ABBREVIATED PLAT AGENDA

October 30, 2024

**STAFF REVIEW AND RECOMMENDATIONS
PUBLIC HEARING
OCTOBER 30, 2024**

PRELIMINARY PLAT: LAZY SLUMBER
LEGAL DESCRIPTION: SEC 22, T18N, R02E, SEWARD MERIDIAN AK
PETITIONERS: ERON SINGLETON
SURVEYOR/ENGINEER: DENALI NORTH
ACRES: 12.08 ± PARCELS: 2
REVIEWED BY: NATASHA HEINDEL CASE #: 2024-108

JOB NO. 24-013PP DATE: JUNE 4, 2024 DW: HW CHK: WW
SCALE 1" = 60' FB: 274/47 SHEET 1 OF 1

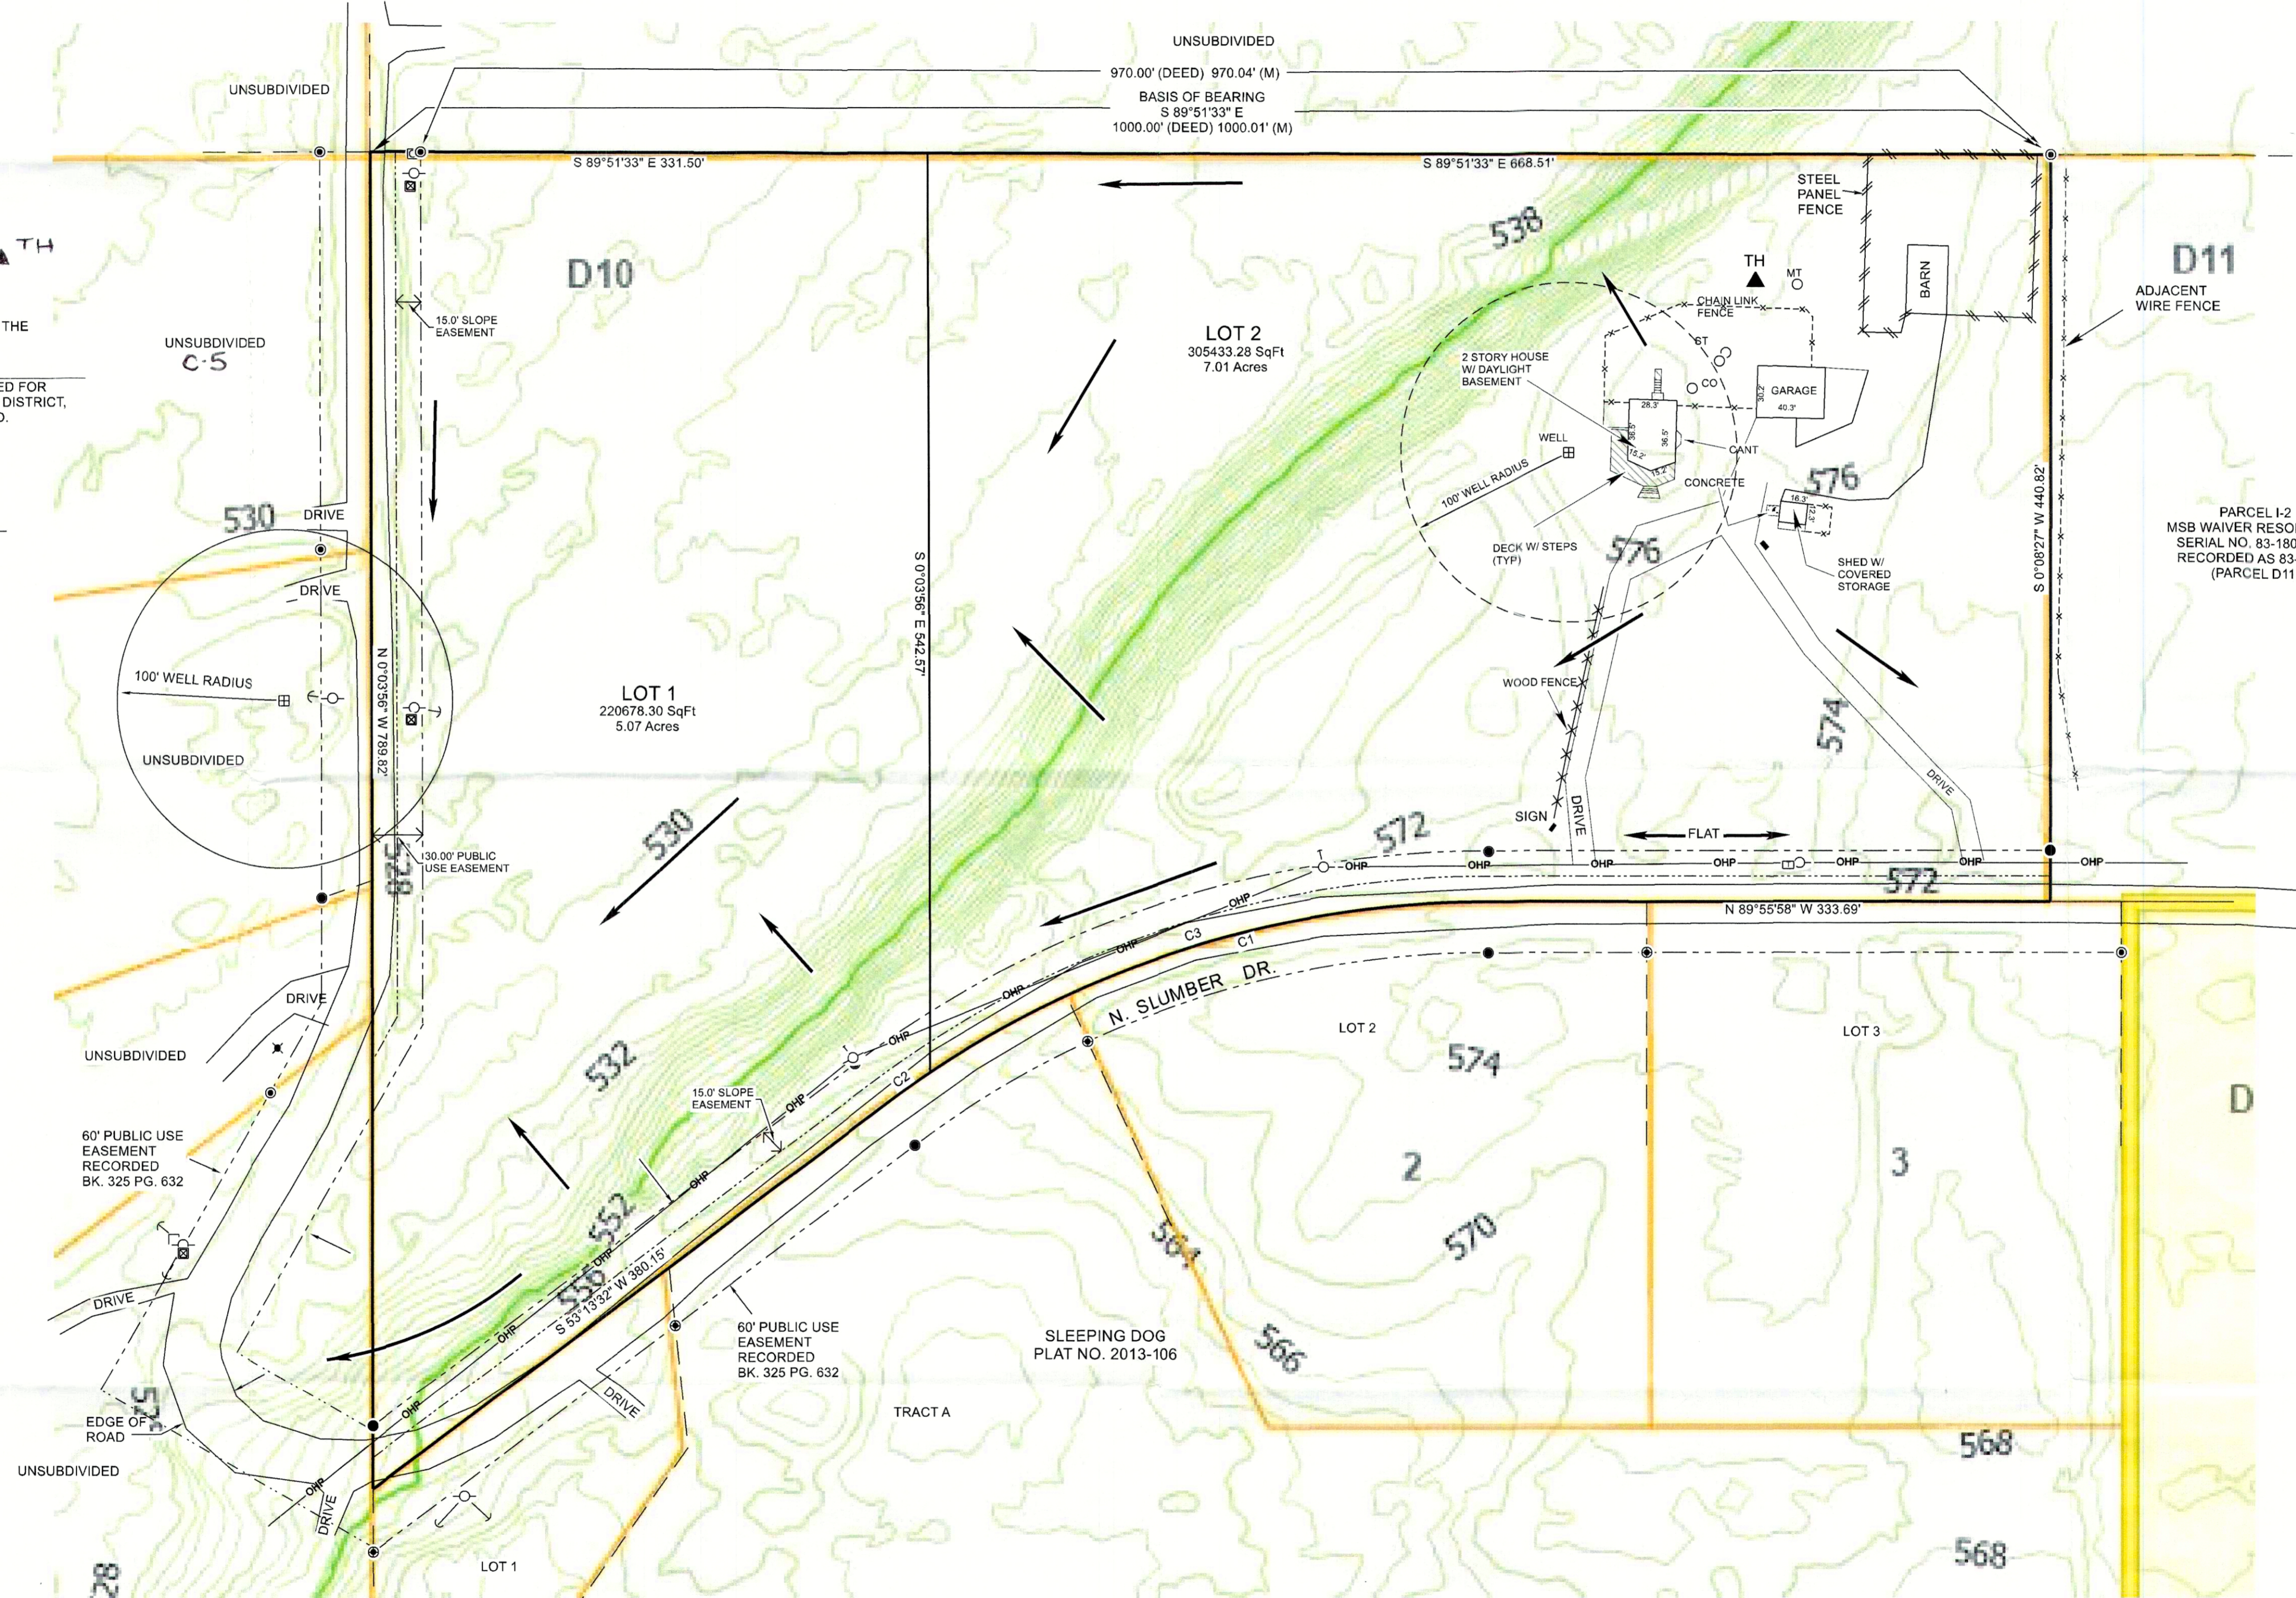
U.S. Army Corps of Engineers (USACE) (Exhibit C) stated that the subject property may require authorization from the Corps if the owner plans to develop there as there appears to be waters of the U.S. on site. A Department of Army (DA) authorization is required if anyone proposes to place dredged and/or fill material into waters of the US, including wetlands and/or perform work in navigable waters of the US. A copy of the DA permit application can be found online. Section 404 of the Clean Water Act requires that a DA permit be obtained for the placement or discharge of dredged and/or fill material into waters of the U.S., including jurisdictional wetlands (33 U.S.C. 1344). Section 10 of the Rivers and Harbors Act of 1899 requires a DA permit be obtained for structures or work in or affecting navigable waters of the US (33 USC 403). Section 10 waters are those waters subject to the ebb and flow of the tide shoreward to the mean high water mark, and/or other waters identified by the Alaska District. Aquaculture structures and work would require Section 10 Authorization.

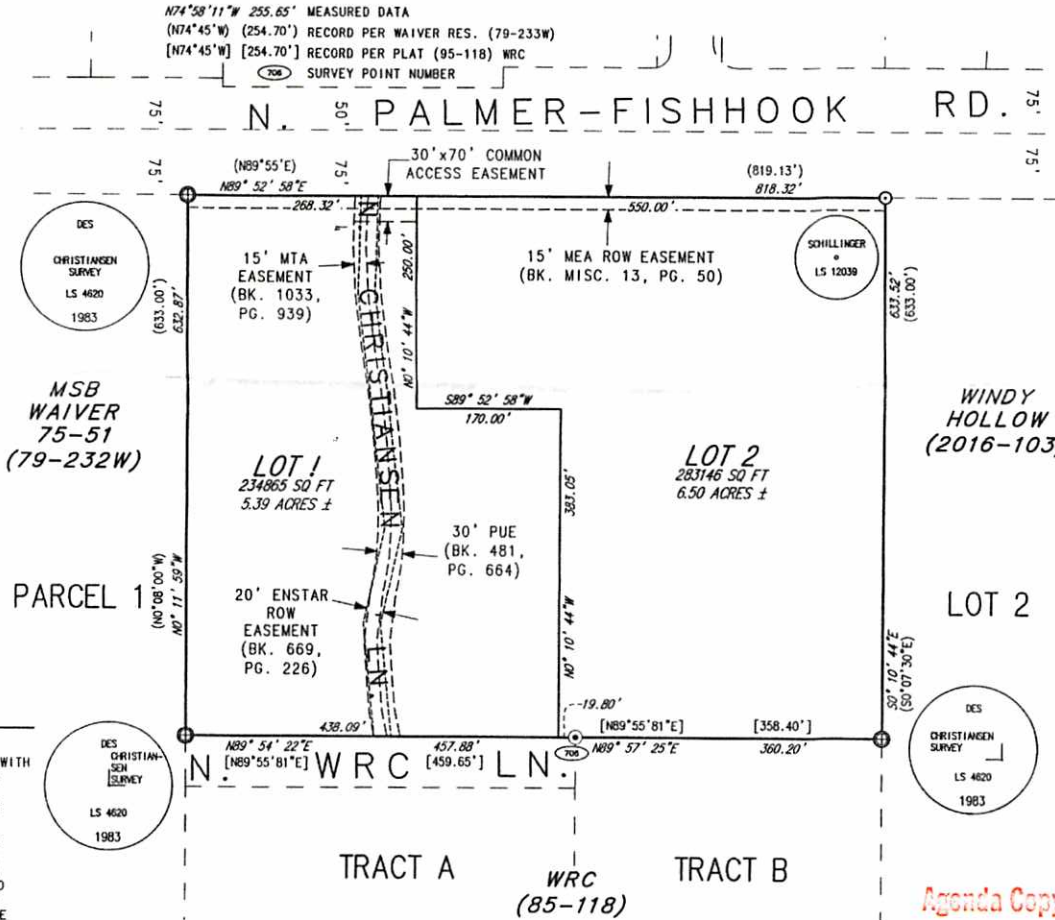
ADOT&PF (**Exhibit C**) No objection to the proposed lot division. Lot 1 and Lot 2 access must be through Christiansen Lane. Please add plat note: “No direct access for Lots 1 or 2 to Palmer-Fishhook Road.” *Staff note this is recommendation # 3.*

- **Fishhook Airstream; PA 05 HLS-Airstream; MSB Waiver 75-72 recorded as 79-233W; Clyde A. Lee Jr & Peggy Lee (Palmer-Fishhook Road)**
 - No objection to the proposed lot division.
 - Lot 1 and Lot 2 access must be through Christiansen Lane.
 - Please add plat note: "No direct access for Lots 1 or 2 to Palmer-Fishhook Road."
 - DOT&PF recommends lengthening common access easement south to avoid future queuing issues.

Drawn by: CAJ Scale: 1" = 160'
Field Book: 129/103 Date: 9/23/2024

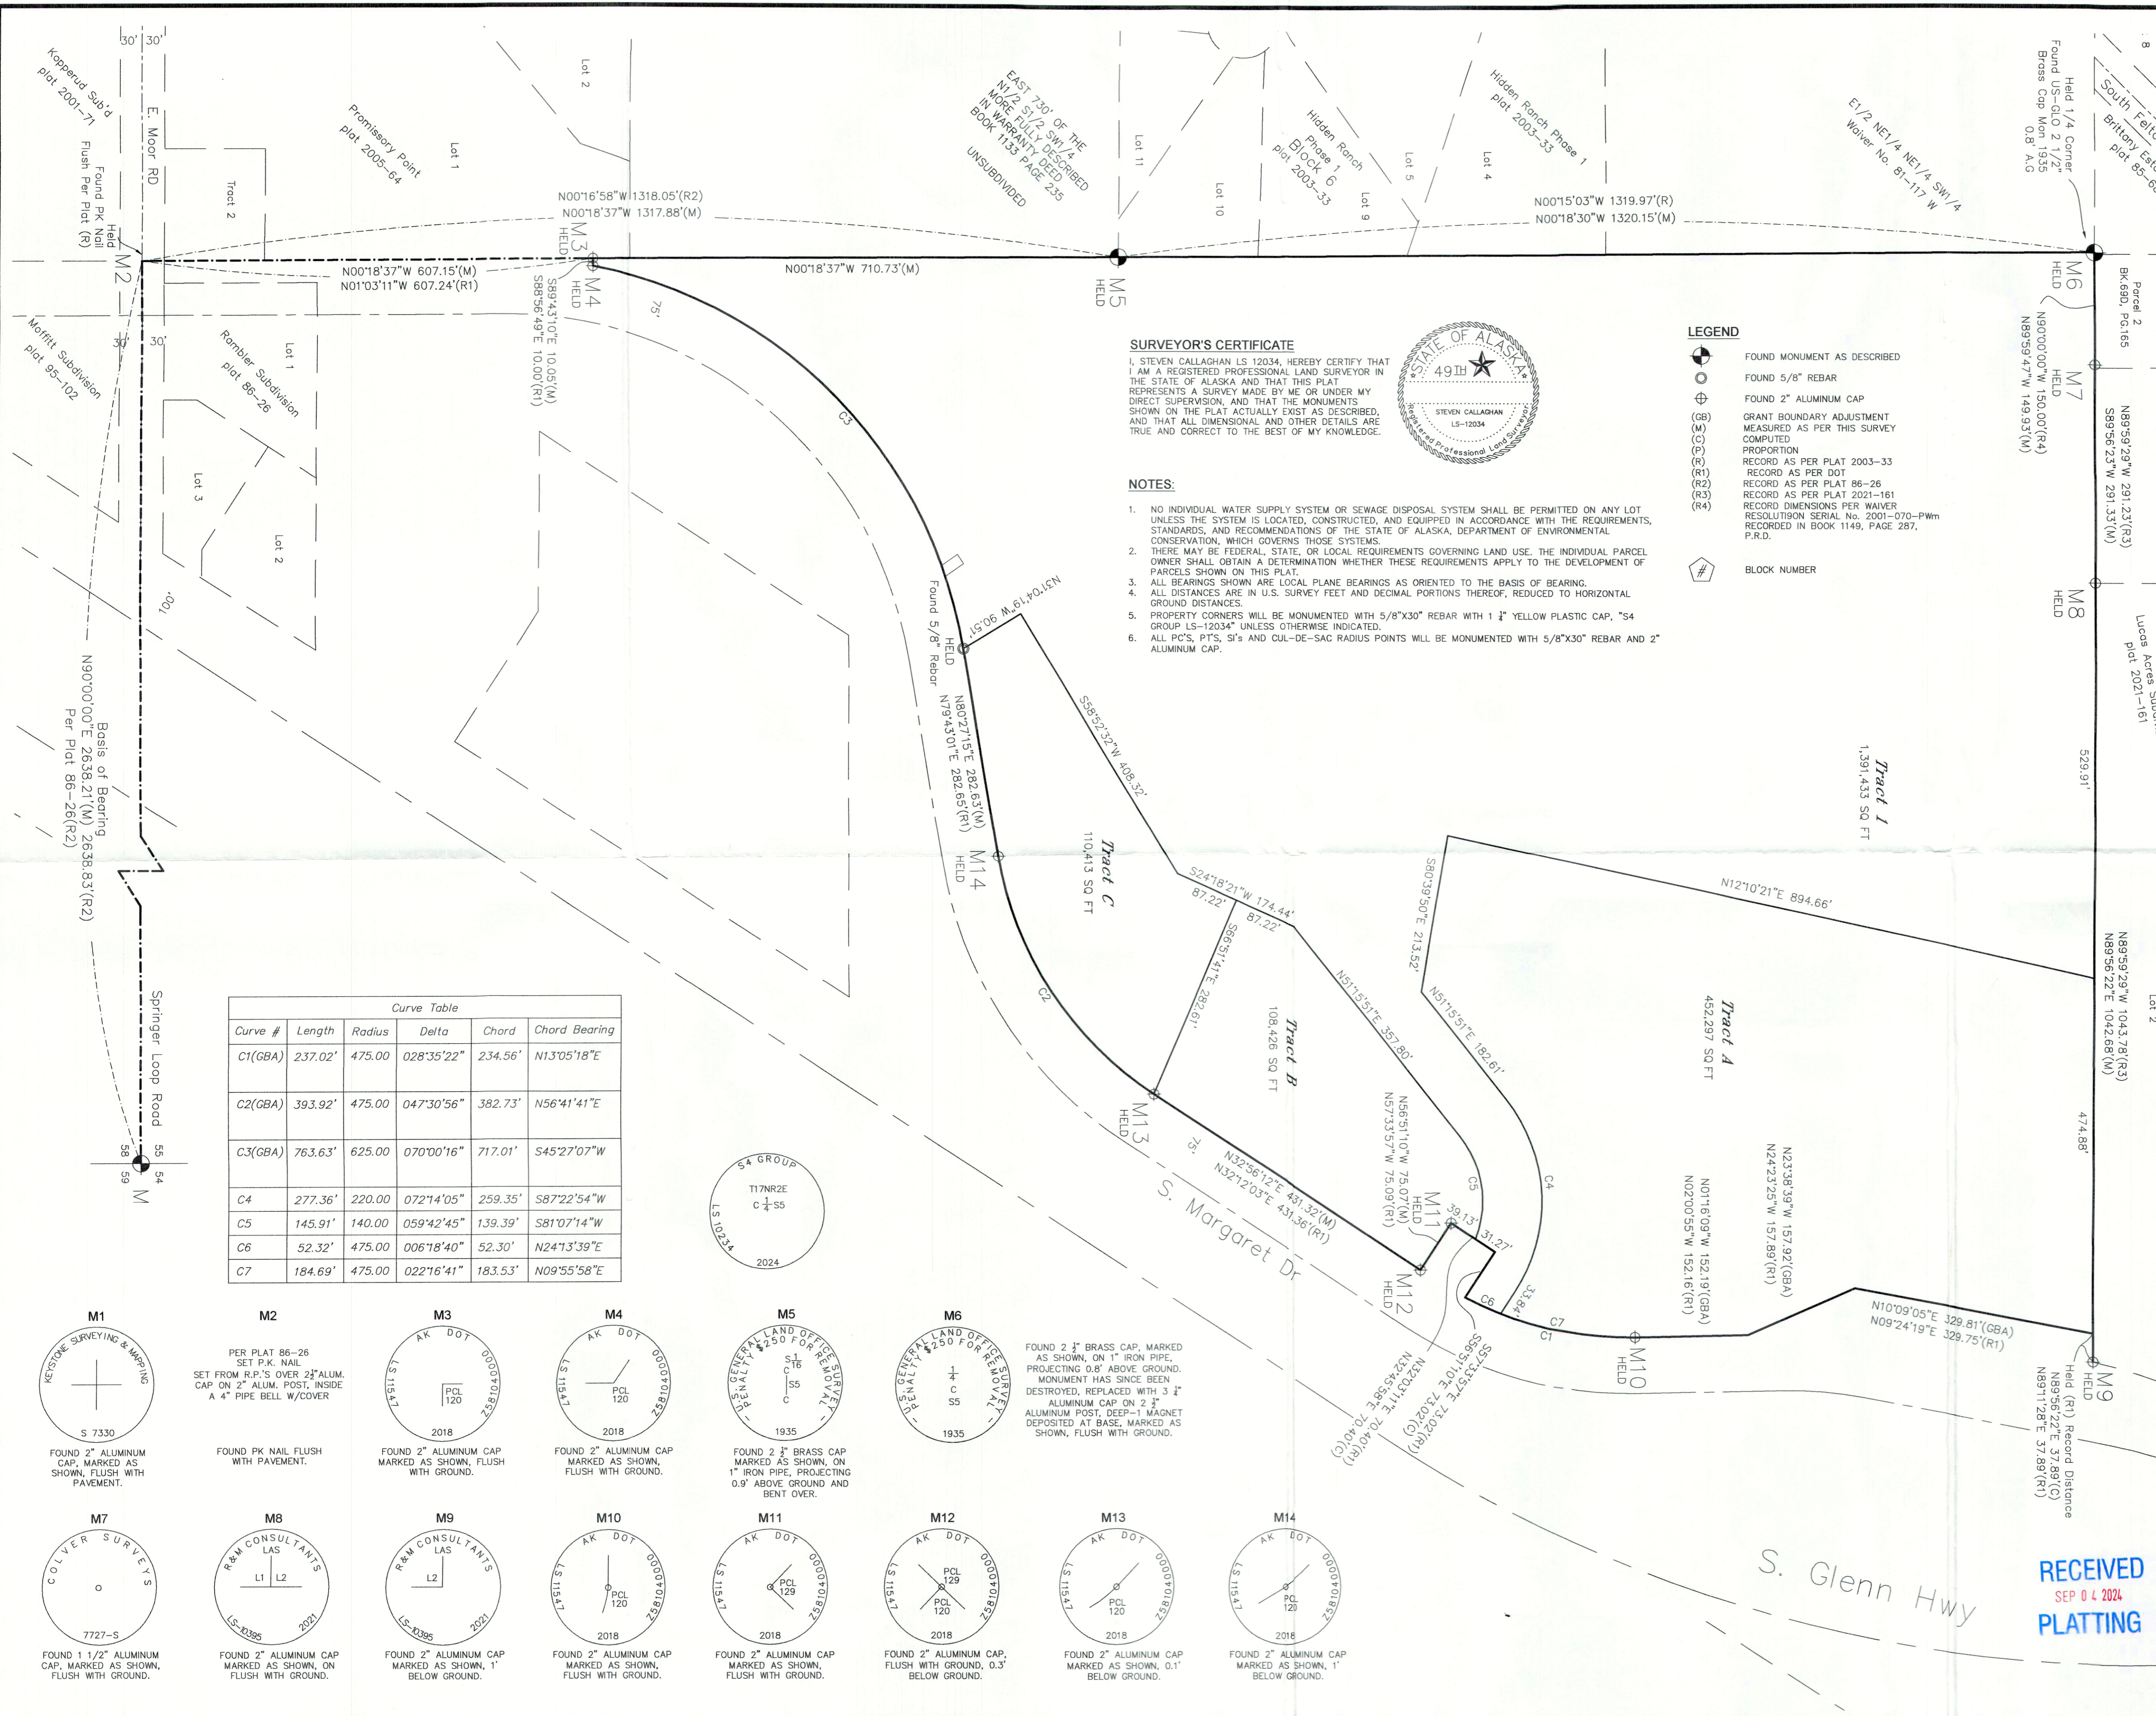
ENSTAR notes that there is existing high pressure transmission pipeline located within the right of way of S. Margaret Drive and requests plat notes be added advising any future development will require contacting the Alaska Digline prior to excavation. *Platting staff notes that the requested plat note would not be appropriate as it involves end land use.*

MTA requests a 15' utility easement be granted along the north property line of Tract A and a 15' utility easement along the southern property line of Tract C. *Platting staff notes that utility easements cannot be granted on an abbreviated plat. The petitioner will need to work with MTA to record the requested easement and show the recorded information on the final plat (Recommendation #4).*

ENSTAR Natural Gas Company, LLC has reviewed abbreviated plat **TRACT A , B, C, D KERTTULA SUBDIVISION (MSB Case # 2024-117)** and advises that there is an existing Alaska Pipeline Company, LLC (APC) high pressure transmission pipeline located within the S. Margaret Drive. ROW bordering the eastern boundary of proposed Tract 1, A, B, and C. APC requests that the following notes be added:
